Project Name Skye Canyon LVMPD Substation & Park **Proposed Use** Police substation & Park

Design Review Committee
1635 Village Center Circle, Suite 100
Las Vegas, NV 89134
O (702) 242-4949 • F (702) 242-0414

RE: Providence Master-Planned Community
Pod 104A – CLV Sky Canyon LVMPD Substation and Park
Overall Site Plan, Overall Landscape Plan, Exterior Elevations and Color Boards
– 1st Submittal
Plans dated: No dates indicated.
Submitted (via email): December 5, 2024

OVERALL LANDSCAPE PLAN

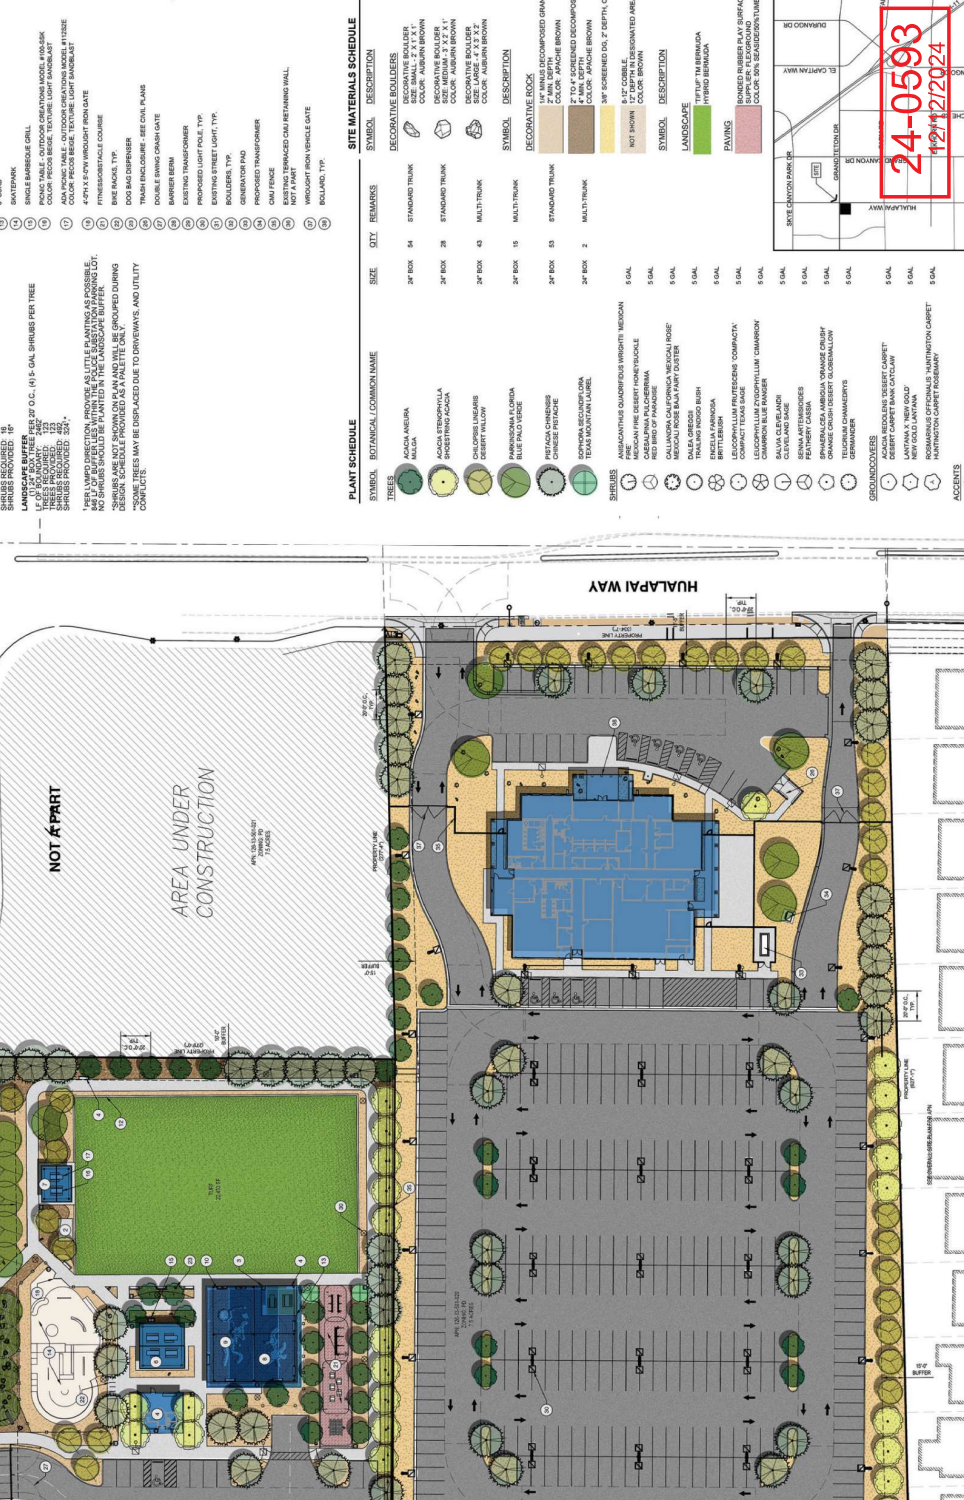
1. The approved rock color for the entire Providence community is *Rebel Rose*. To maintain continuity of the streetscapes along the Hualapai Way and Grand Teton Rd. frontages, please continue this color at least within the 25-foot-wide streetscape buffers.

2. While the proposed shrubs, groundcovers and accent plants are depicted in the landscape plan's plant schedule, none are shown in the landscaped areas of the substation or park site. The vegetative cover should result in a minimum of 50% coverage after one year's growth.

3. Correctly dimension the 25-foot-wide landscape buffer along Hualapai Way and reflect the existing streetscape landscaping as was done for the same on the Grand Teton Dr. frontage.

4. Please clarify proposed configuration of the walls abutting the adjacent Green Valley Grocery parcel and confirm that the proposed materials and colors for those and the wall between the park and the substation will be in reasonable adherence with the "Wall Palette" table (Exhibit "H" of the *Cliff's Edge Design Guidelines*, dated August 5, 2009).

2 SIDE ELEVATION

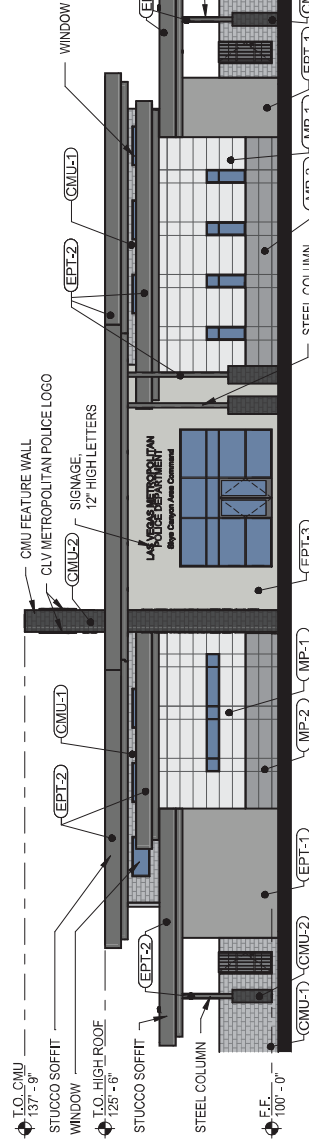
While the proposed architectural design and colors of the substation building and its front return walls/gates deviate from the Providence architectural themes and color schemes, the DRC finds that the facility will nonetheless present a professional appearance befitting of a police substation and will be an attractive addition to the Providence community and the surrounding area. These documents are both DRC-**approved**.
